PCV Modification to 1998-2000 Volvo 2.4L B5244S Engines

The AERA Technical Committee offers the following information regarding a PCV (positive crankcase ventilation) modification for 1998-2000 Volvo 2.4L B5244S engines. This modification became factory issue beginning with engine serial number 139320 (approximately chassis number 098900).

Figure 1. PCV Hose Modification

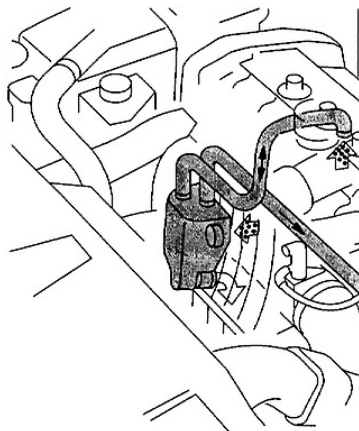
An additional hose was added from the oil trap to the cylinder head during the 2000 model year. Only the later type of cylinder heads and engine are available as replacement parts from Volvo. Updating all earlier cylinder heads is suggested for an enhanced PCV system.

When replacing a cylinder head or engine, the crankcase ventilation must be upgraded to the later type.

- The later type of oil trap must be installed when replacing a cylinder head.
- A hose must be installed from the oil trap to the cylinder head.
- A new ignition cable kit with a longer cable must also be installed
